Project	<b>IEEE 802.16 Broadband Wireless Access Working Group</b> < <a href="http://ieee802.org/16">http://ieee802.org/16</a> >	
Title	<b>MBS_DATA_Time_Diversity_IE Corrections</b>	
Date Submitted	<b>2008-01-14</b>	
Source(s)	Lei Wang, Sina Zahedi, Yair Bourlas, Wee Peng Goh  NextWave Broadband	Voice: [Telephone Number (optional)] E-mail: <a href="mailto:lwang@nextwave.com">lwang@nextwave.com</a> ; <a href="mailto:ybourlas@nextwave.com">ybourlas@nextwave.com</a> ; <a href="mailto:wgoh@nextwave.com">wgoh@nextwave.com</a> ; <a href="mailto:szahedi@nextwave.com">szahedi@nextwave.com</a>  * <a href="http://standards.ieee.org/faqs/affiliationFAQ.html">http://standards.ieee.org/faqs/affiliationFAQ.html</a> >
Re:	802.16 Working Group Letter Ballot #26a	
Abstract	This document proposes fixes in MBS_DATA_Time_Diversity_IE.	
Purpose	To be discussed and adopted by 802.16 Rev2.	
Notice	<i>This document does not represent the agreed views of the IEEE 802.16 Working Group or any of its subgroups. It represents only the views of the participants listed in the "Source(s)" field above. It is offered as a basis for discussion. It is not binding on the contributor(s), who reserve(s) the right to add

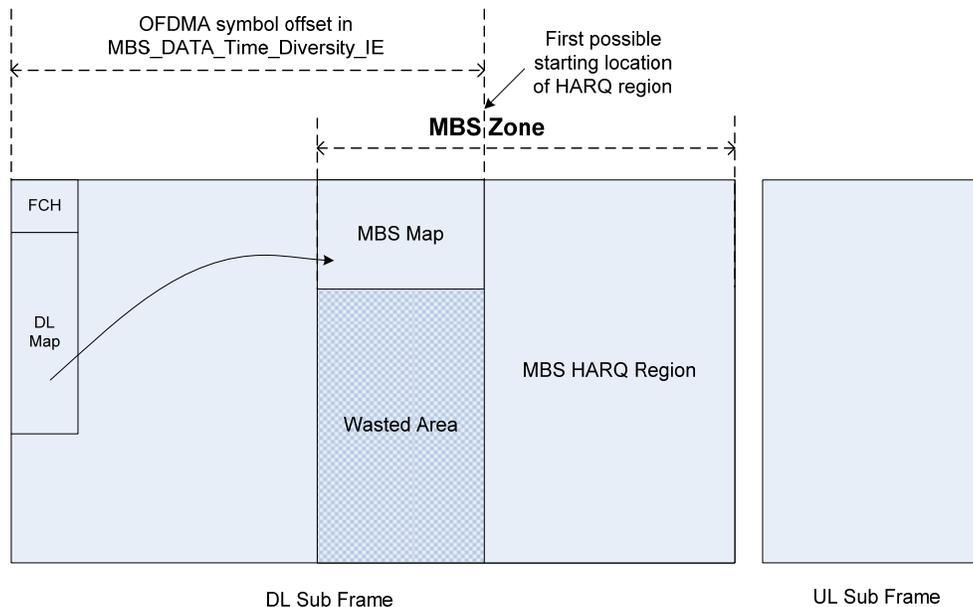
- 1) in Rev2/D2, page 248, Table 157, the field “# of MBS\_DATA\_Time\_Diversity IEs with the same MBS Burst Frame Offset” is incorrect, as it is not the number of the diversity IE itself, it is actually the number of MBS HARQ data sub-bursts;
- 2) The field “OFDMA symbol offset” in MBS\_DATA\_Time\_Diversity IE indicates the starting offset of the MBS HARQ region, and the MBS HARQ region defined by the MBS\_DATA\_Time\_Diversity\_IE spans over the entire set of subchannels. As a result, the OFDMA symbol offset of the starting location of the HARQ region need to point to a symbol after the last symbol occupying the MBS map. Using this method, the area under the MBS map remains unused. Note that the MBS MAP allocation is specified as a block allocation by the MBS MAP IE in the DL MAP. Depending on the shape of MBS MAP allocation, such a waste could be serious as shown in the figure below.

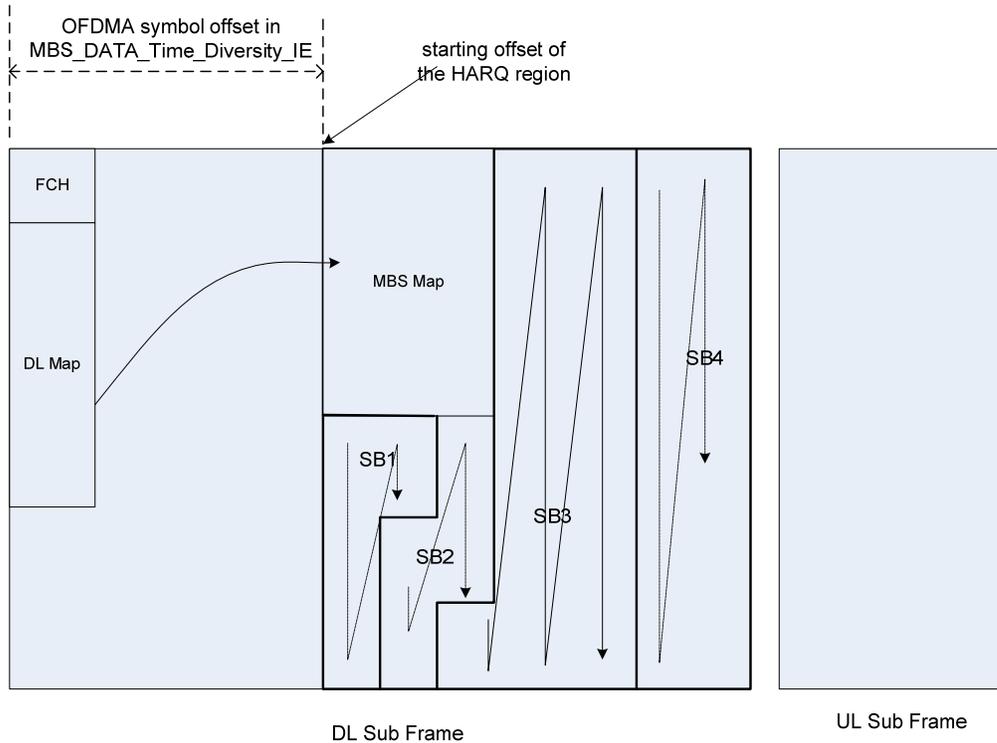
- 1) in Rev2/D2, page 248, Table 157, change the field name “# of MBS\_DATA\_Time\_Diversity IEs with the same MBS Burst Frame Offset” to “# of MBS HARQ Data sub-bursts”;
- 2) change the interpretation of MBS HARQ region defined by the parameter “OFDMA symbol

offset” so that the full MBS region can be utilized: first to allow the HARQ region to start at the same time as the MBS MAP in the same MBS zone if there are subchannels remains unoccupied by the MBS MAP; then allow MBS HARQ data sub-bursts in this region start right after the MBS MAP, i.e., at the subchannel logically numbered after the largest subchannel occupied by the MBS map and will continue in that manner until all symbol groups in the MBS map are full, as shown in the figure below.
